ADDENDUM NO. 3

March 6, 2026

NOTRE DAME CSS -
COSMETOLOGY &
CULINARY ARTS
INTERIOR RENOVATION

Figure 1: View of asbestos black door glazing putty (typical) associated with main door of the Cosmetology Room.

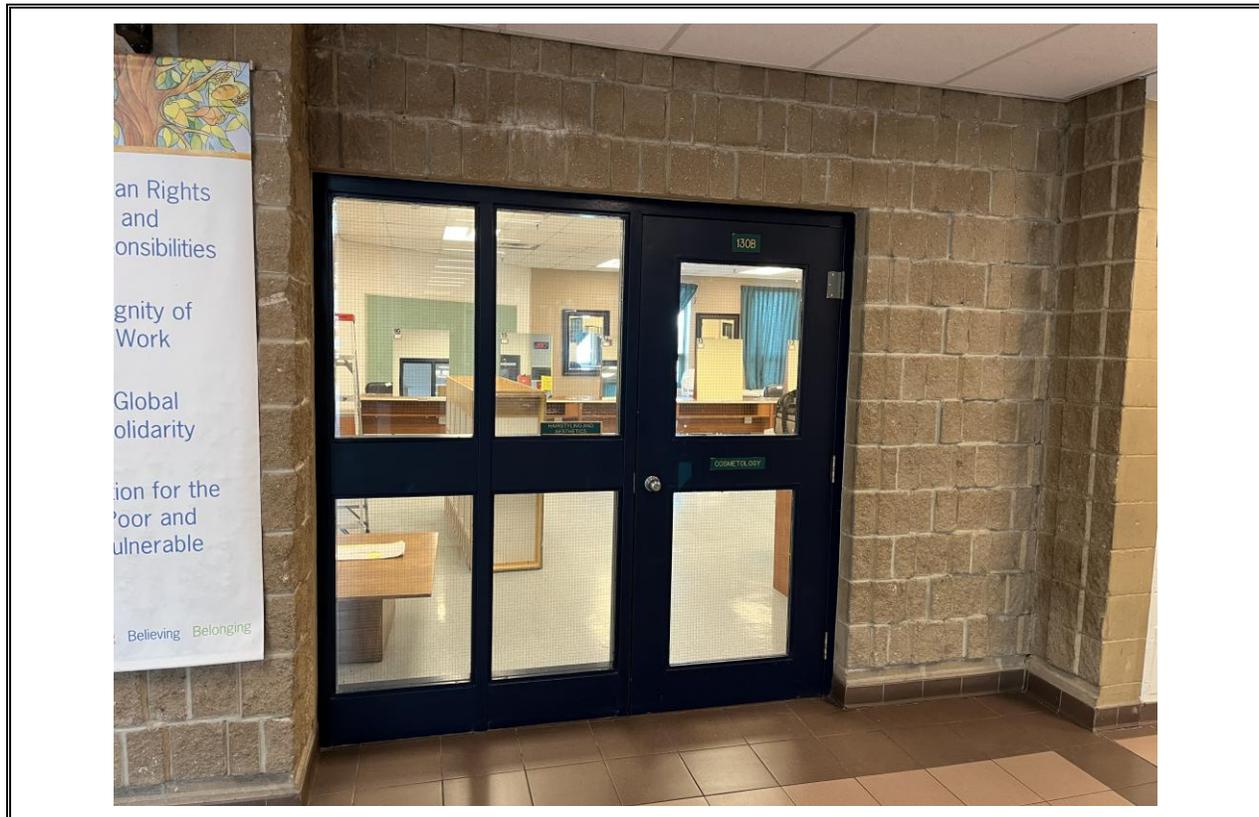
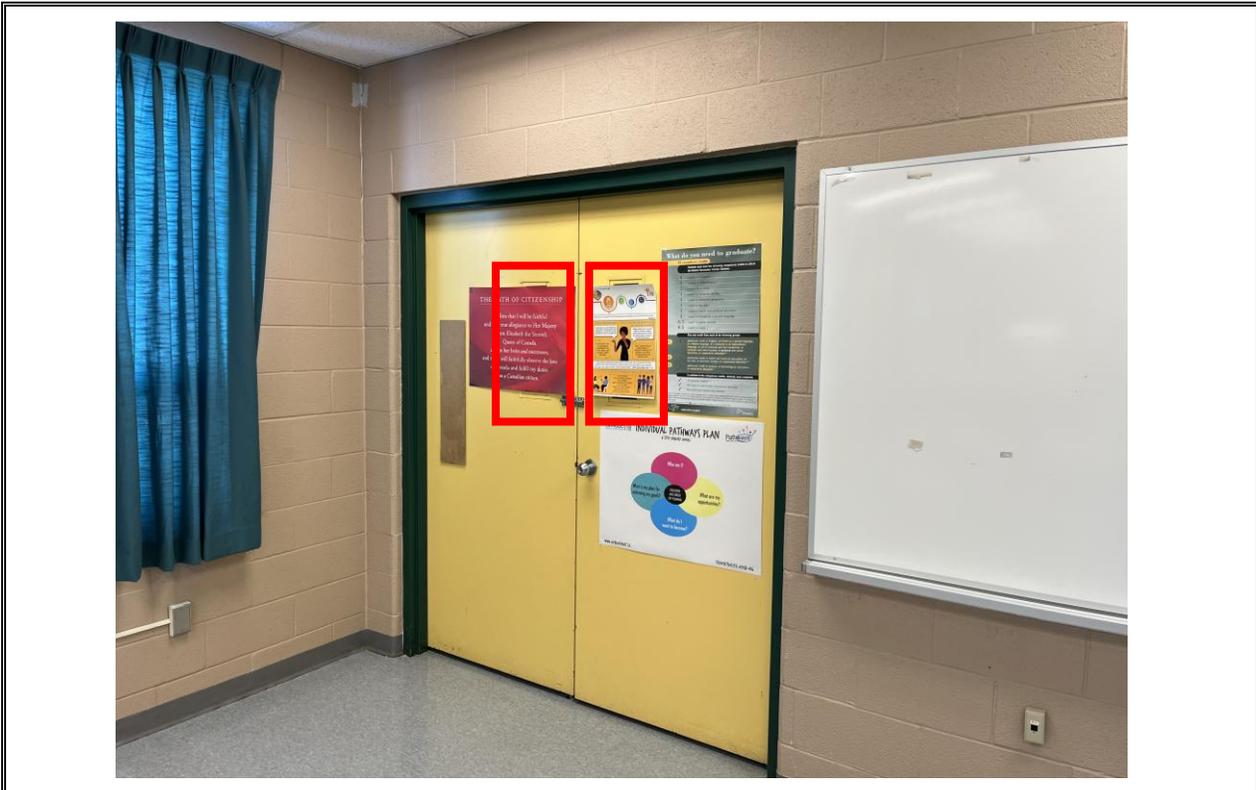
1.4.1 Using Type 1 asbestos procedures remove and dispose of the following from the Cosmetology Room:

1.4.1.1 **1 door assembly set (Main Door)** common the Corridor as depicted in Figure 1 below.

1.4.1.2 **2 doors only** as depicted in Figure 2 below.

1.4.1.3 **1 door only** common with the Corridor as depicted in Figure 4 below.

1.4.1.3.1 The abatement contractor is NOT responsible to remove the door frames shown in Figure 2 and Figure 4 as the door frame caulking does not contain asbestos.

PARTIAL GROUND FLOOR DEMOLITION PLANS

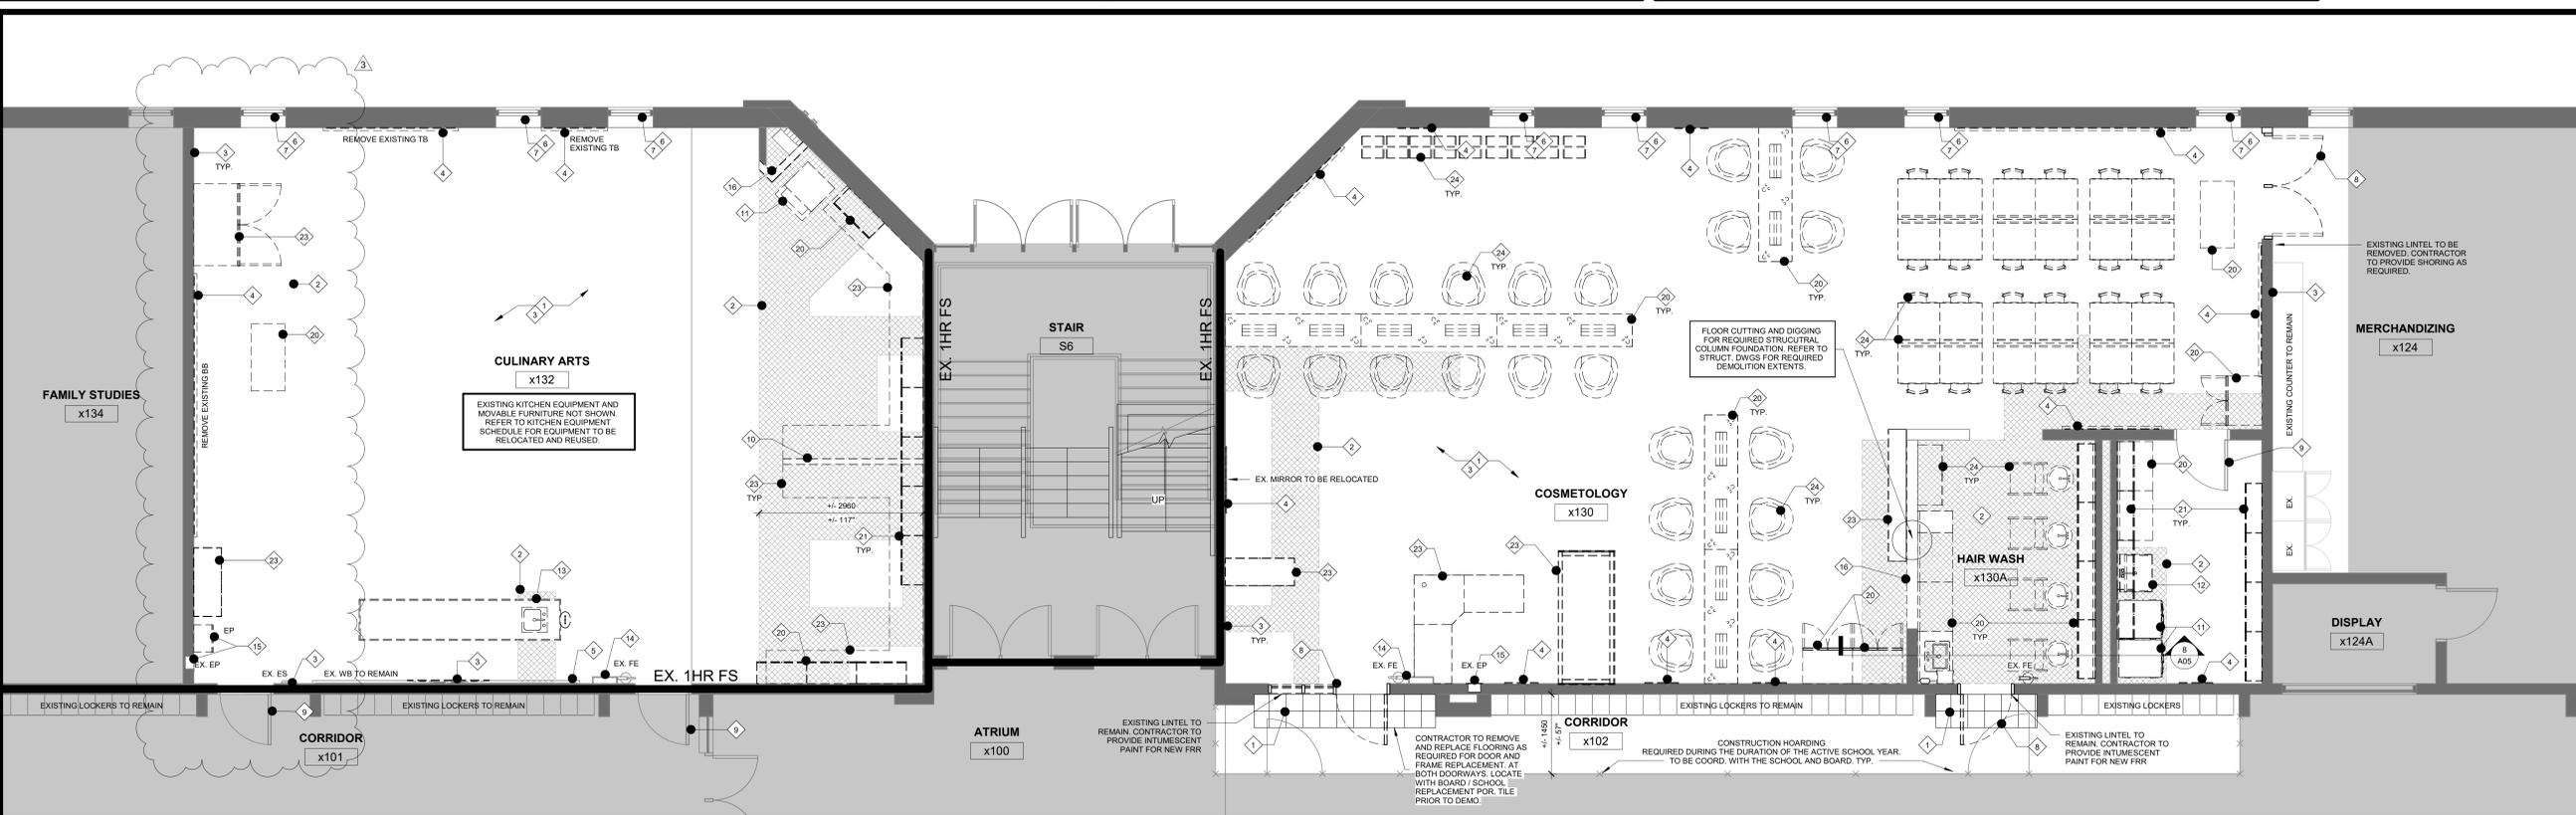
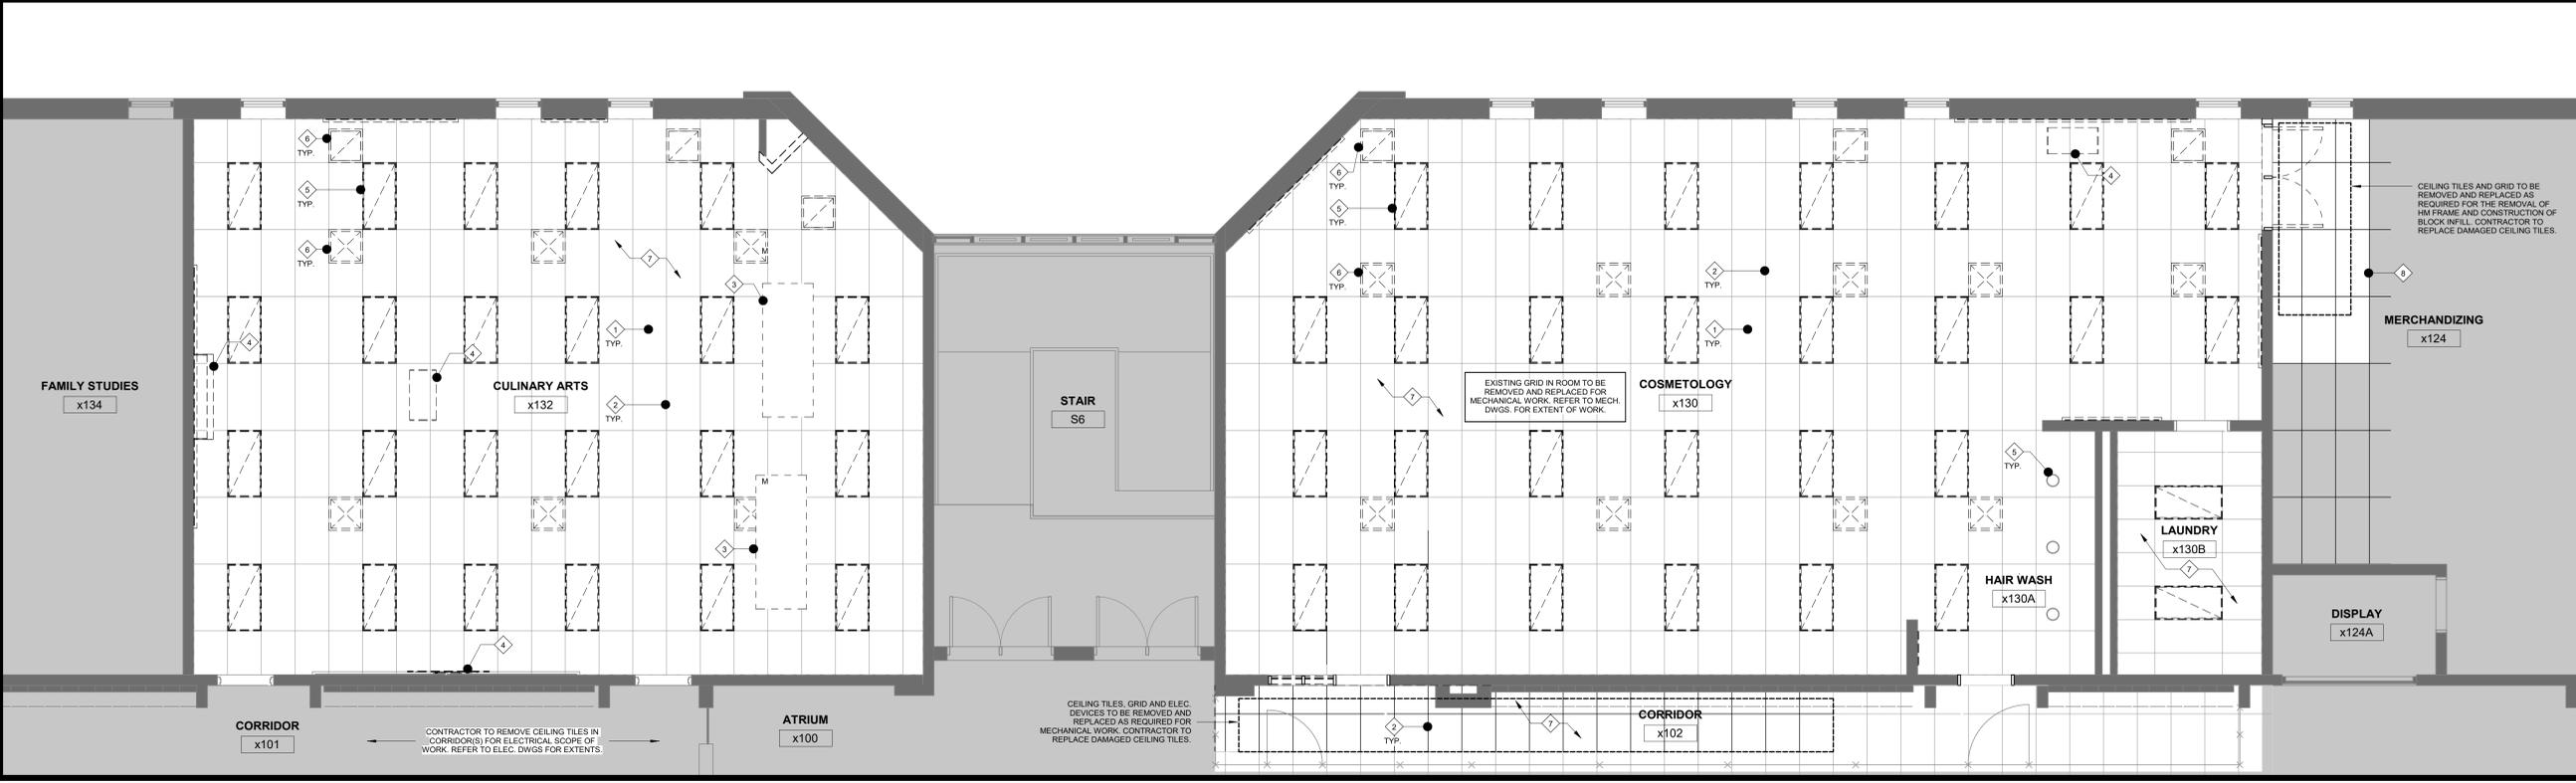
QUESTION 3: Why are we cutting and removing the section of slab on grade at the left side of the existing culinary classroom x132, when there is no new plumbing underground work over there. please confirm?

ANSWER 3: Floor cutting scope of work has been removed. Above ceiling plumbing for exterior hose bib scope of work has been removed. Existing plumbing and hose bib to remain as is.
